**Final
Area of Investigation 6
Remedial Action Completion Report**

**National Aeronautics and Space Administration
Ames Research Center
Moffett Field, CA**

Responses to Comments from EPA and Water Board

Draft Area of Investigation (AOI) 6 Remedial Action Completion Report, NASA Ames Research Center, Moffett Field, CA

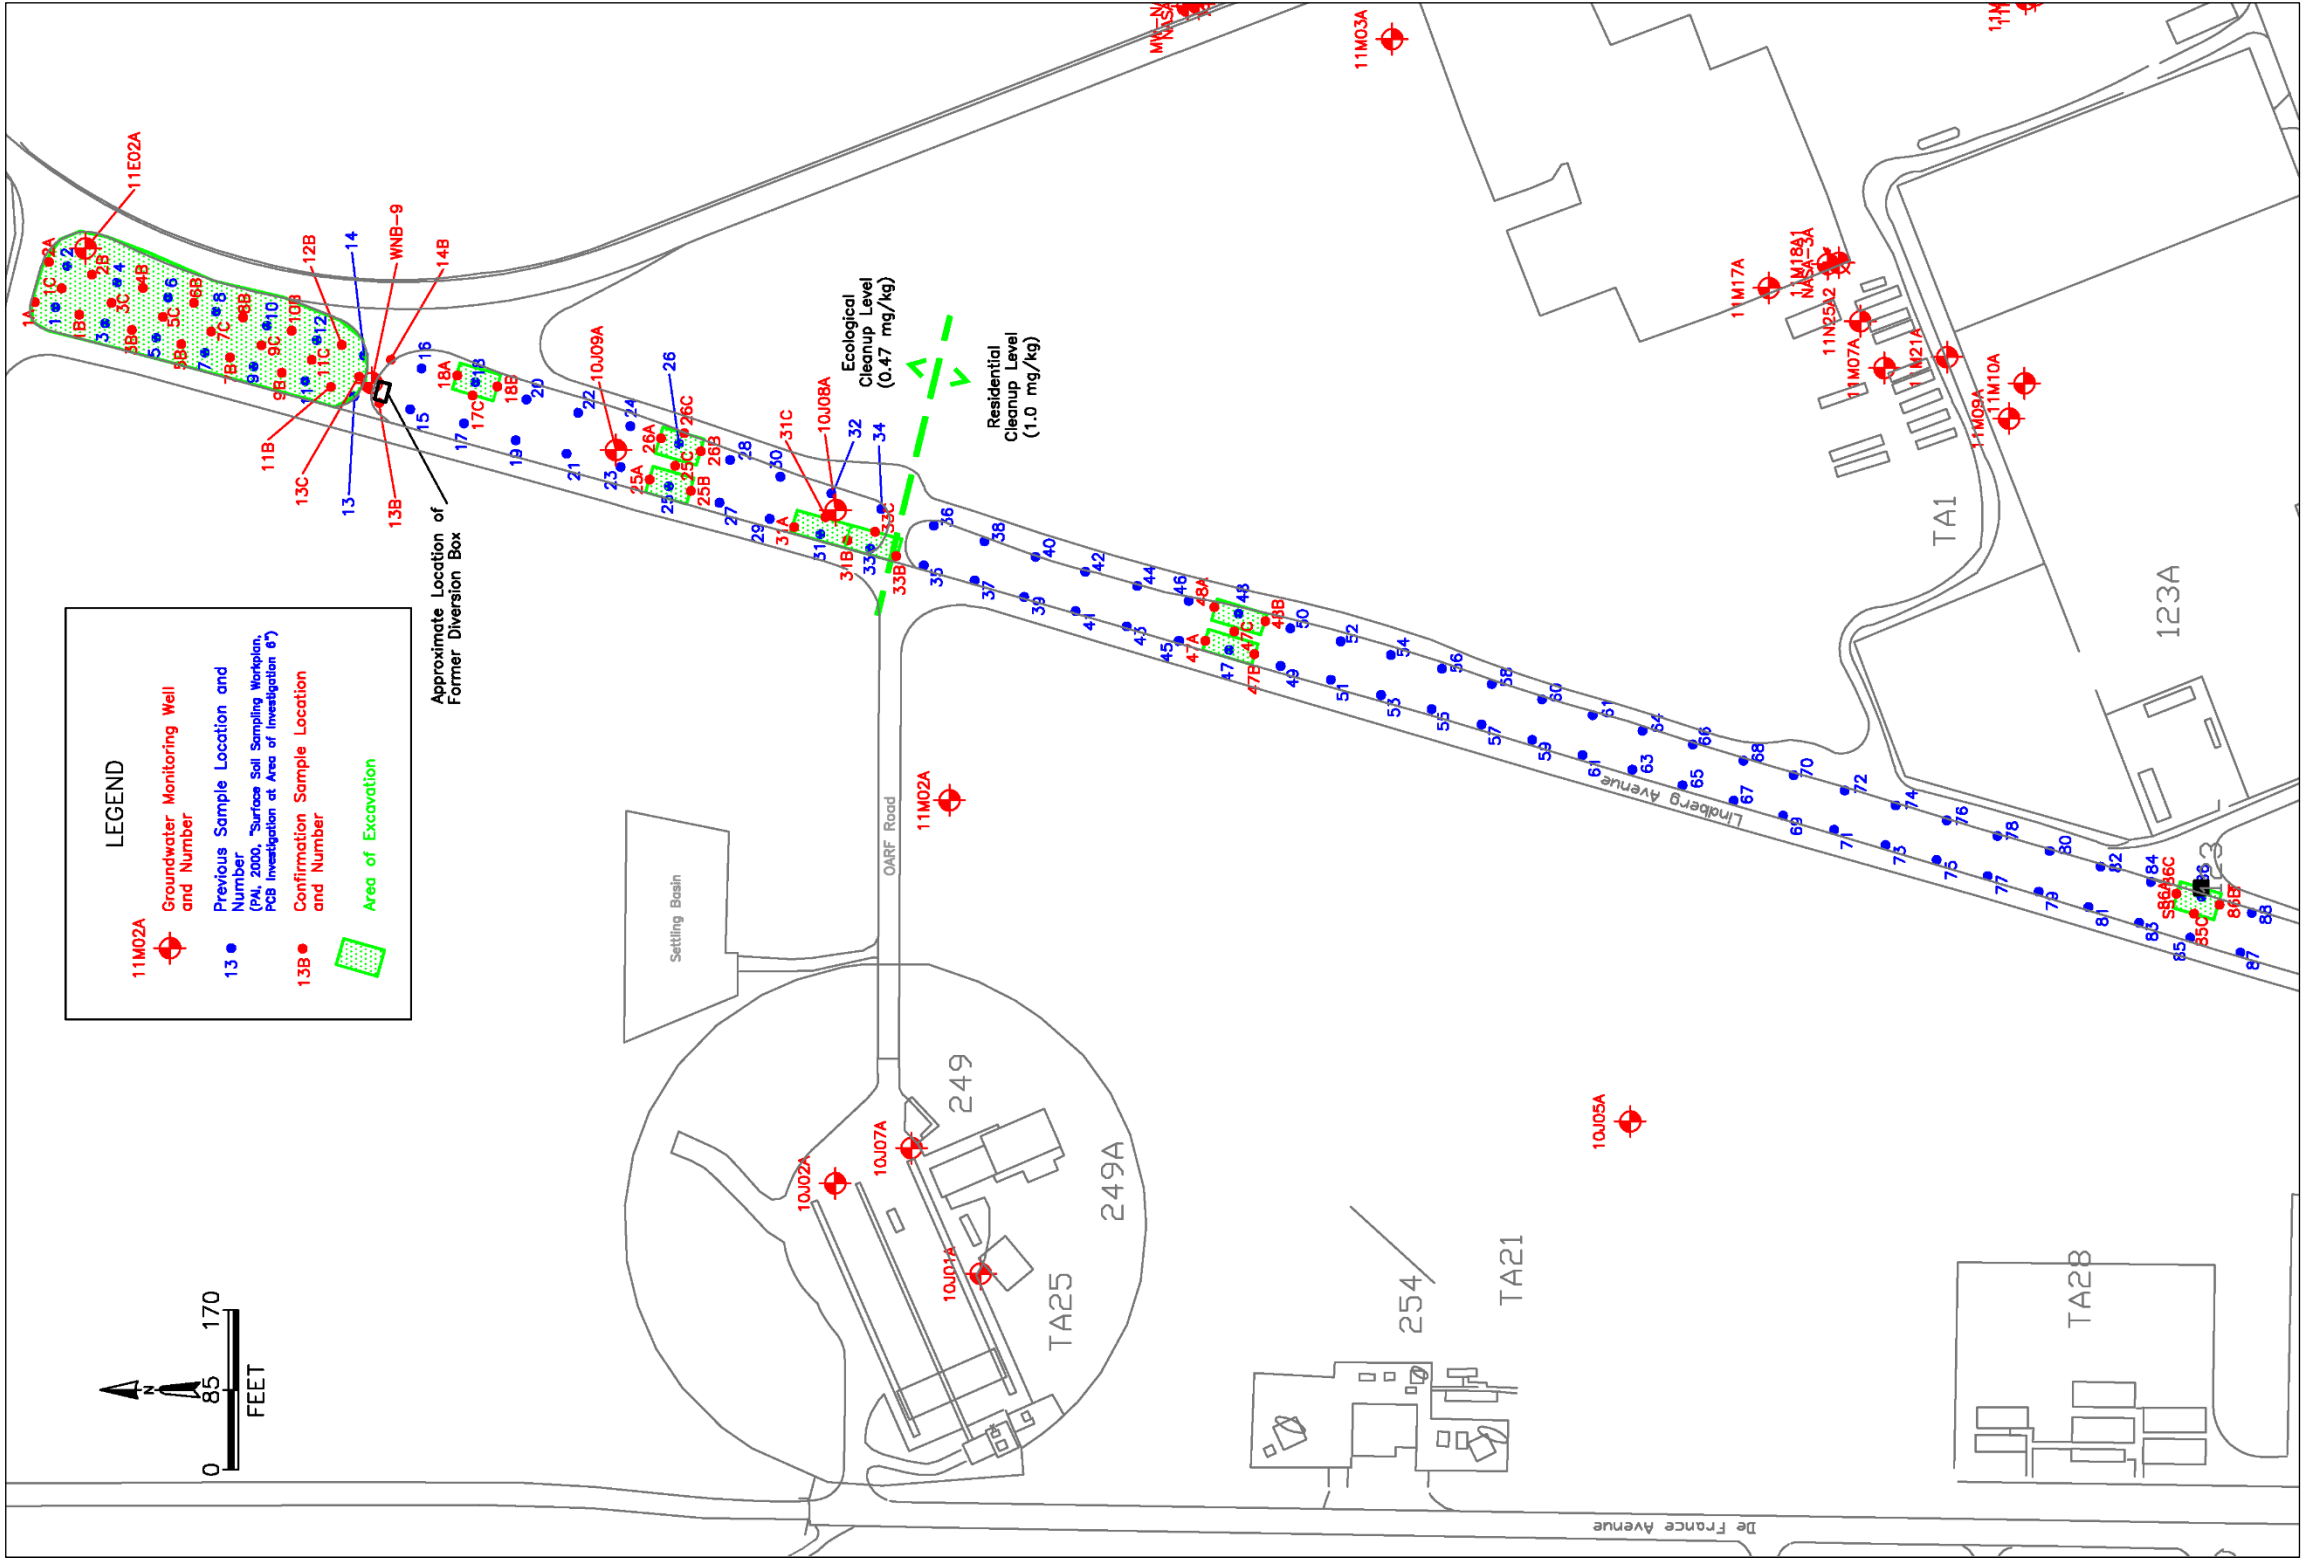
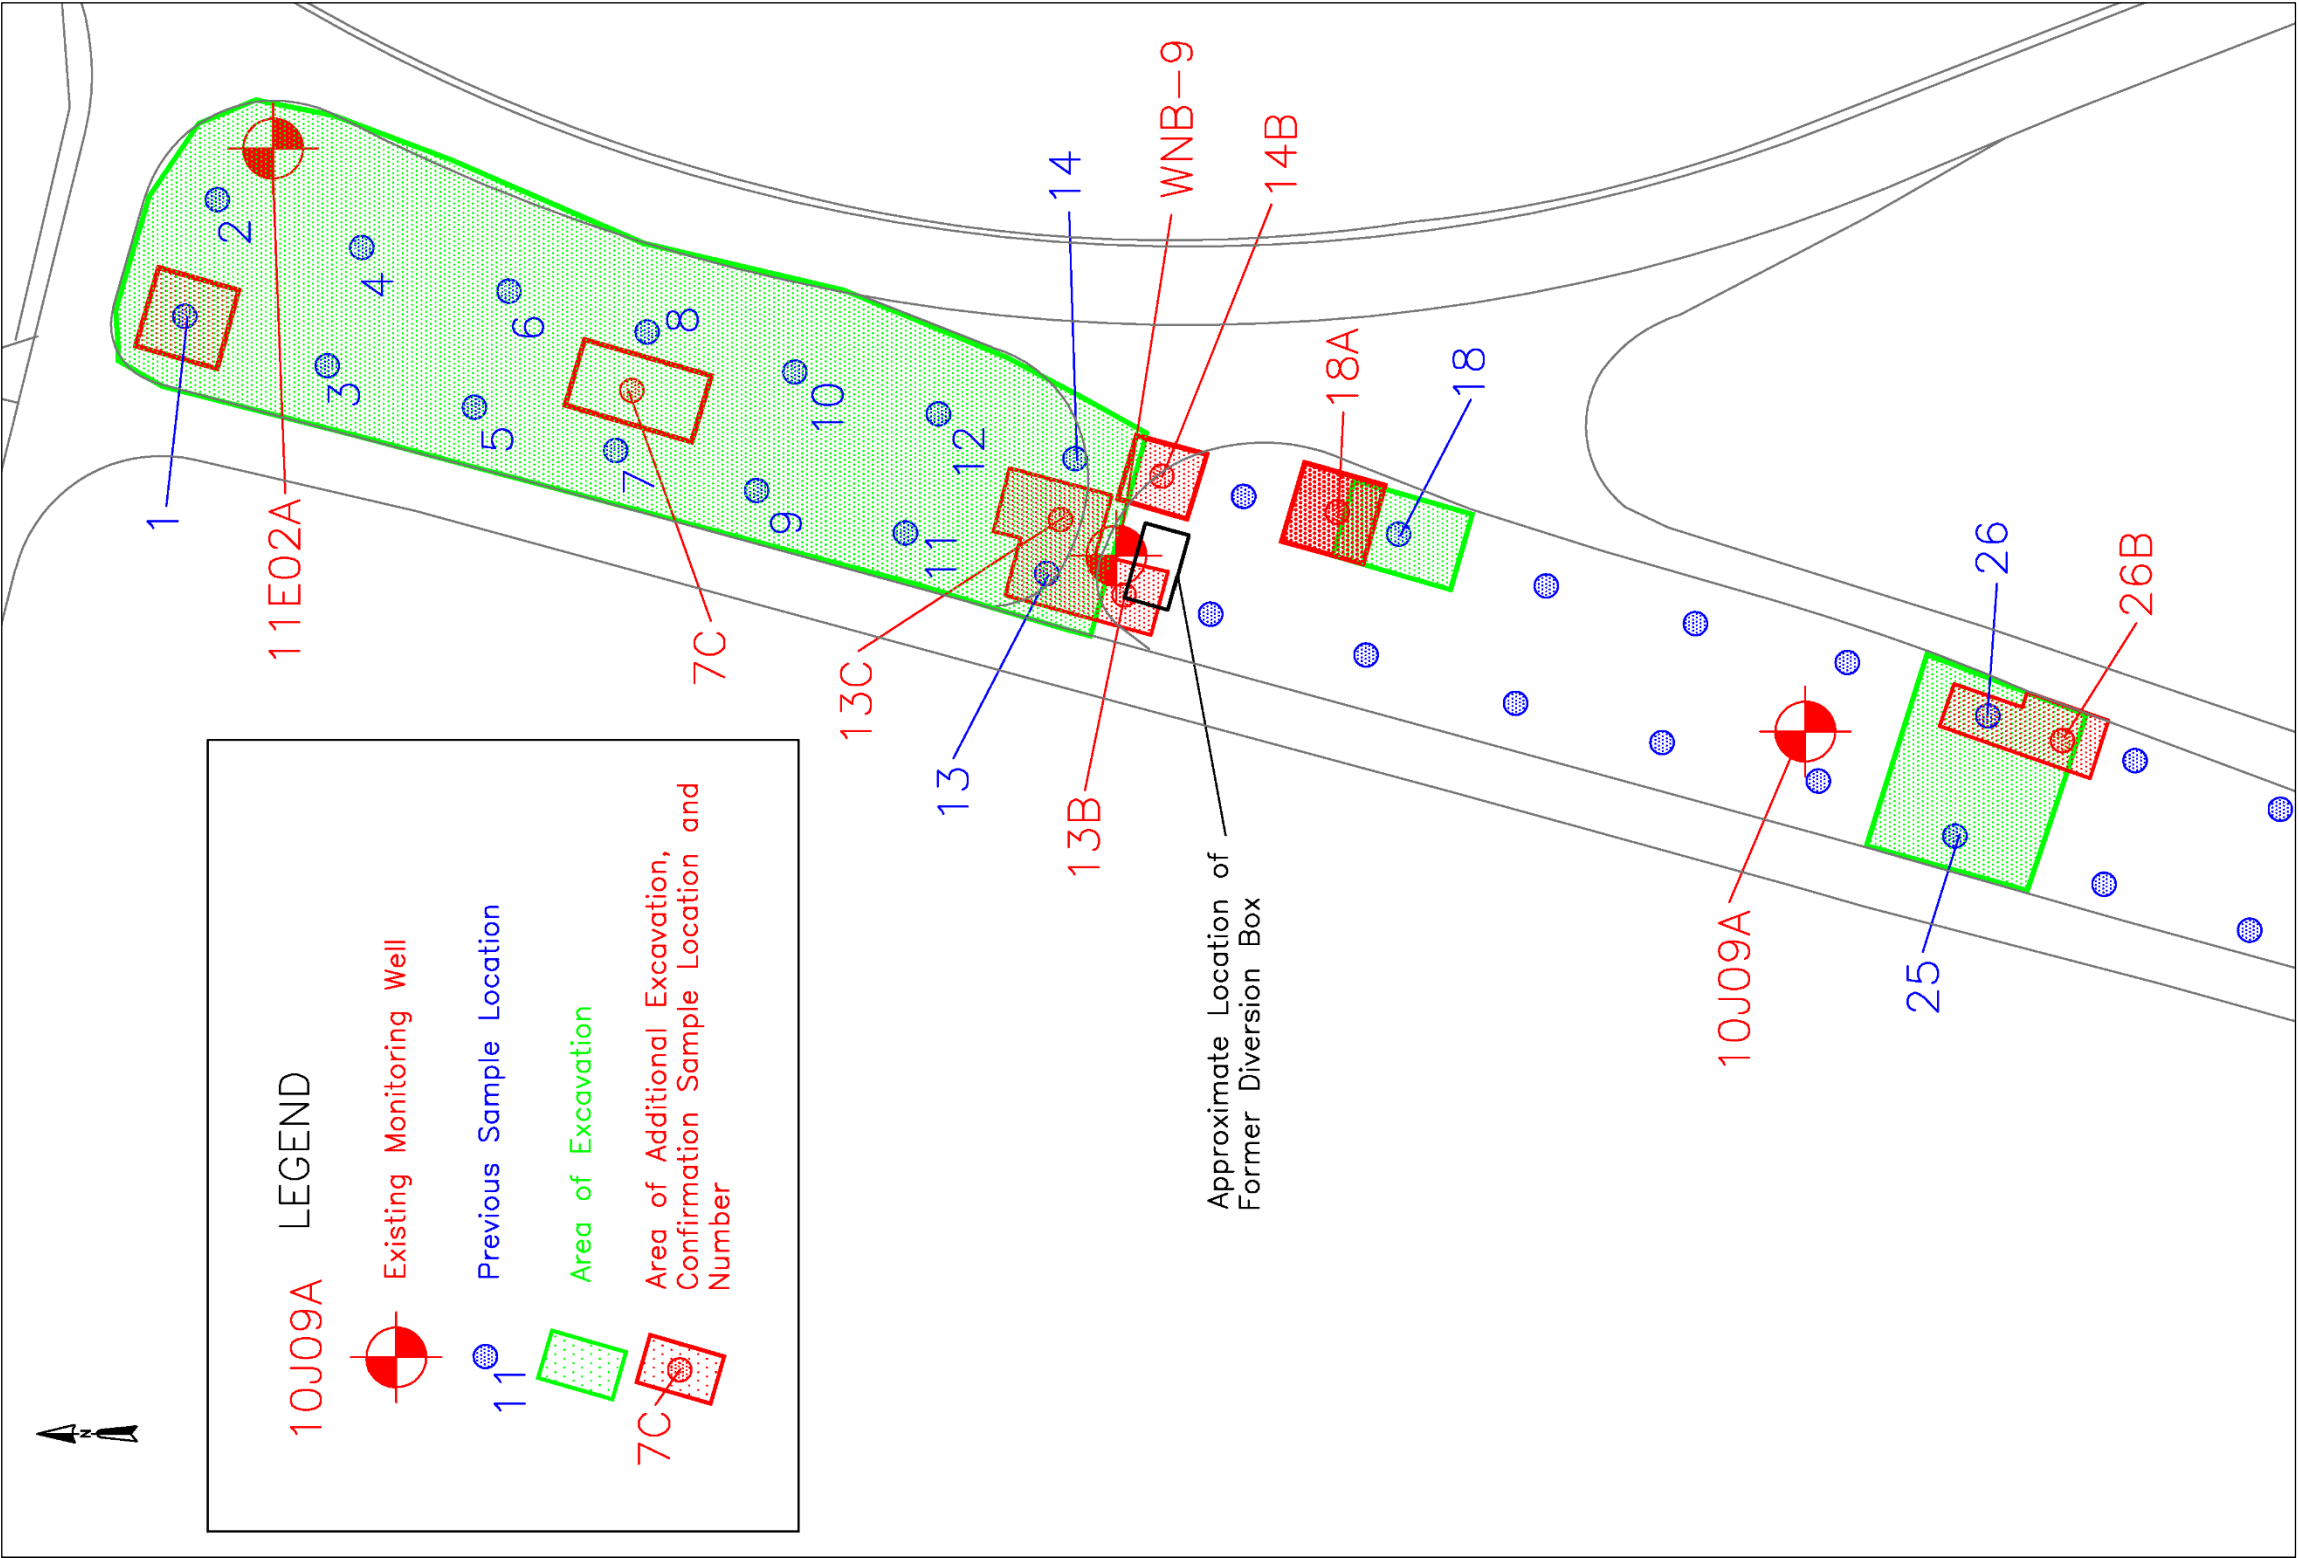
Specific 13.	Section 3.1.5, 2000 Soil Sampling, page 12: The text describes five isolated areas between the diversion box and OARF Road above the ecological cleanup level; however Figures 6 and 7 appear to show four areas between the diversion box and OARF Road. Clarify that the areas around sample locations 31 and 33 are considered two separate areas. This comment also applies to the first paragraph of Section 3.1.6.	The text in sections 3.1.5 and 3.1.6 is revised to clarify that the areas around sample locations 31 and 33 are two separate areas.
Specific 14.	Section 3.1.6, 2001 Soil Sampling, Excavation and Confirmation Sampling, page 12: The first paragraph refers to Figure 8 with regard to confirmation sampling; however, the entire excavation area is not depicted in Figure 8 but in Figure 7. Revise the text and figure to present all confirmation sampling conducted after the initial one foot excavation.	The text in section 3.1.6 correctly refers to Figure 8. Following the excavation of the top one foot of soil as shown in green in Figure 7, confirmation sampling was conducted and nine additional areas were identified as requiring additional excavation (PAI, 2005). The areas requiring additional excavation are shown in red in Figure 8. The text of Section 3.1.6 is revised to clarify the sequence of excavation and sampling.

Figure 8
Sample Locations and Additional 2001 Excavation Area

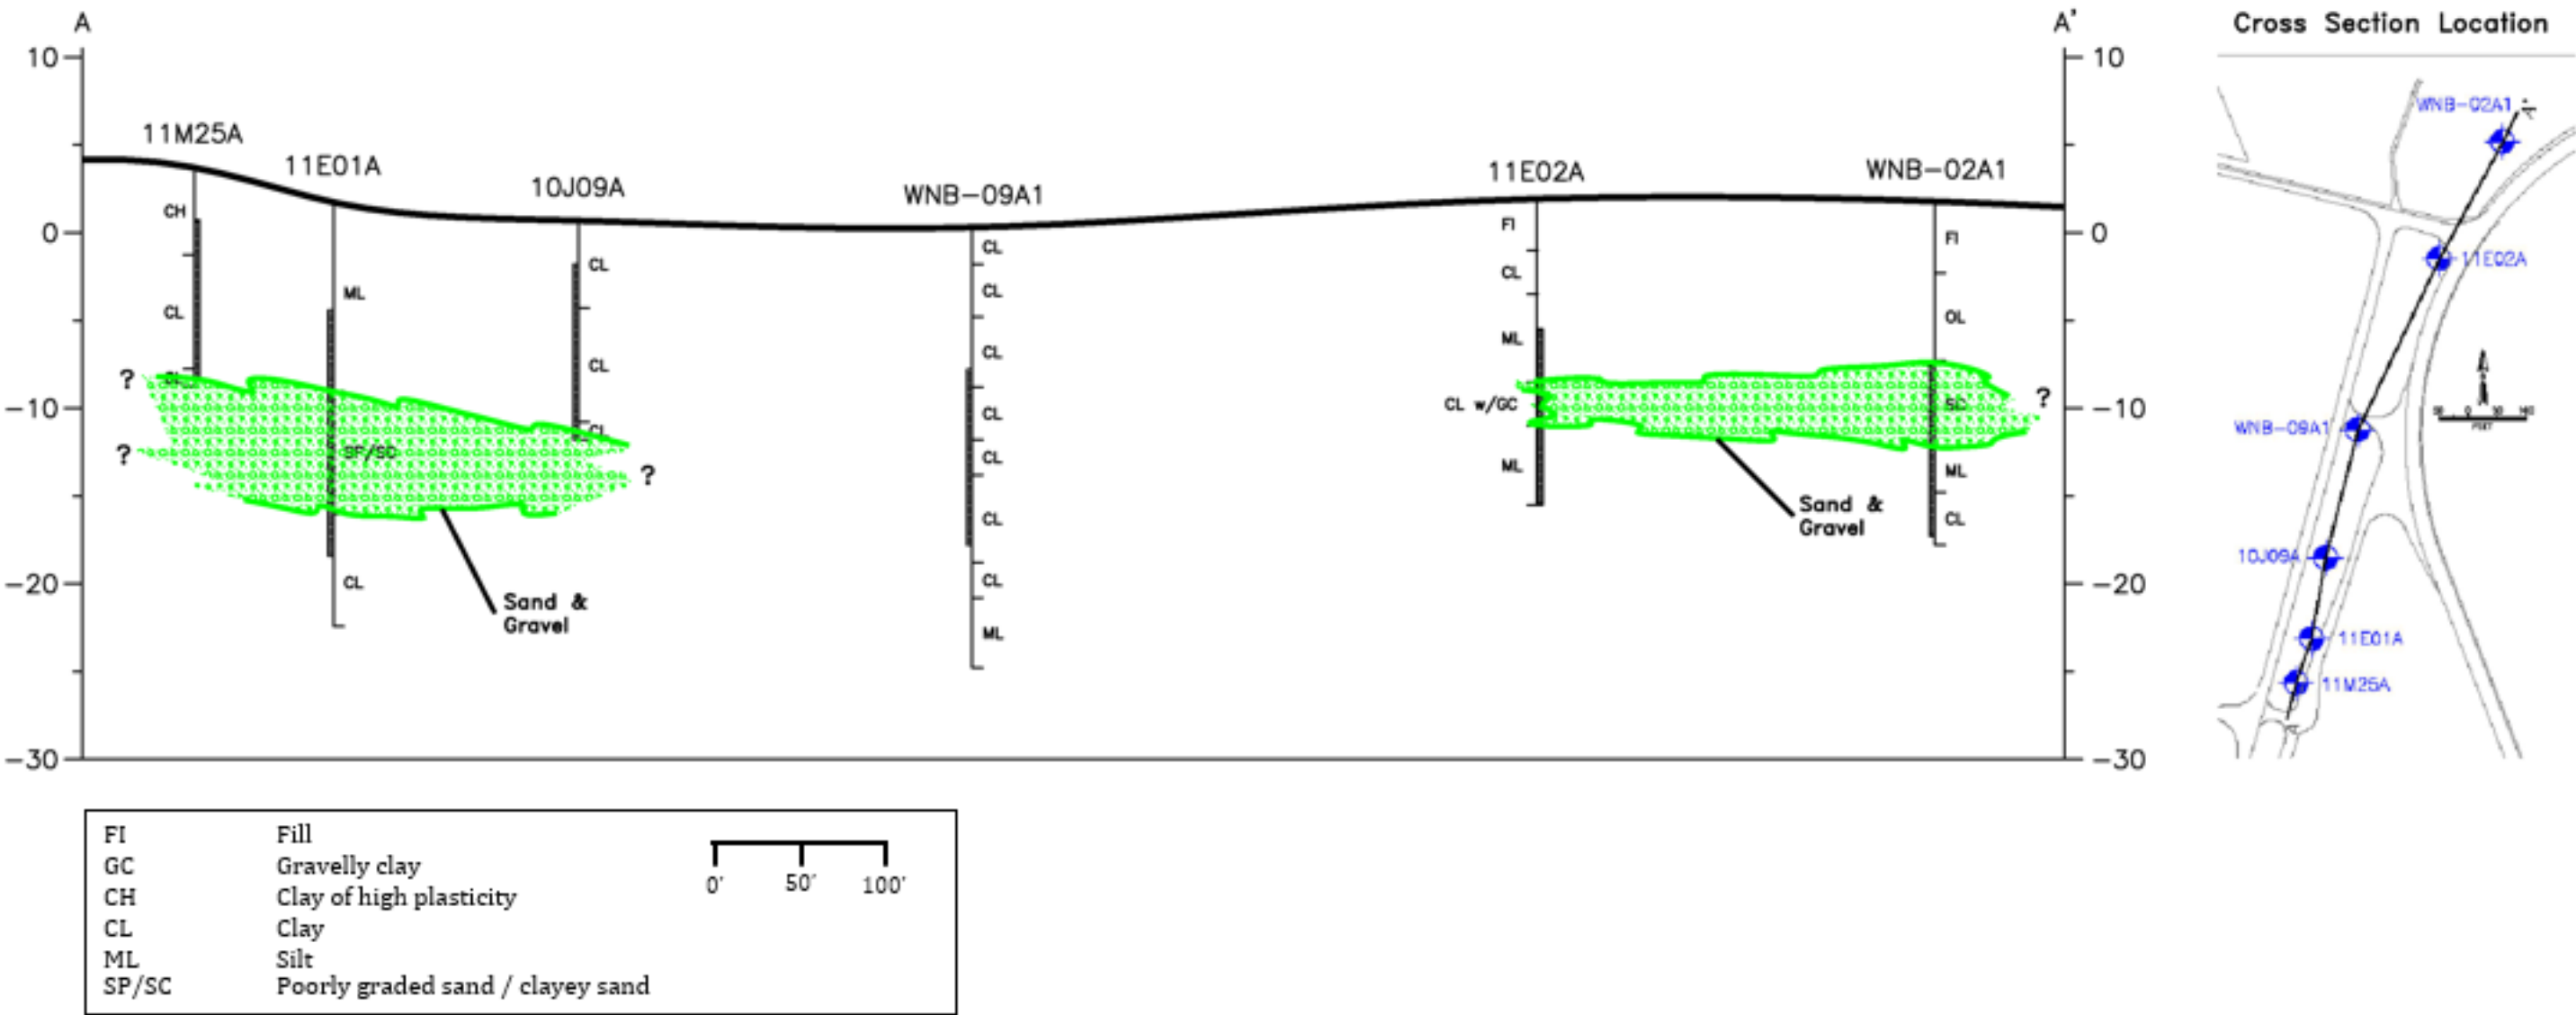
Comment No.	Comment	Response
Responses to Comments from EPA		
General Comments		
Specific 1.	In the last sentence of the first paragraph of Section 2.1, the letter "B" in "Based" should be changed to lower case.	Section 2.1 is revised as requested in this comment.
Specific 2.	As with the description of areas in Sections 3.1.5 and 3.1.6 (see Specific Comment 13 on the Draft RACR) that underwent excavation, clarify that the nine areas described in the third paragraph of Section 3.1.6 (and depicted in red in Figure 8) are each defined by one sampling location. As shown in Figure 8, adjacent areas appear to be a single contiguous area	The text in section 3.1.6 is revised to clarify that the nine areas that required additional excavation were each defined by one sample locations. These separate areas are outlined in red in Figure 8.
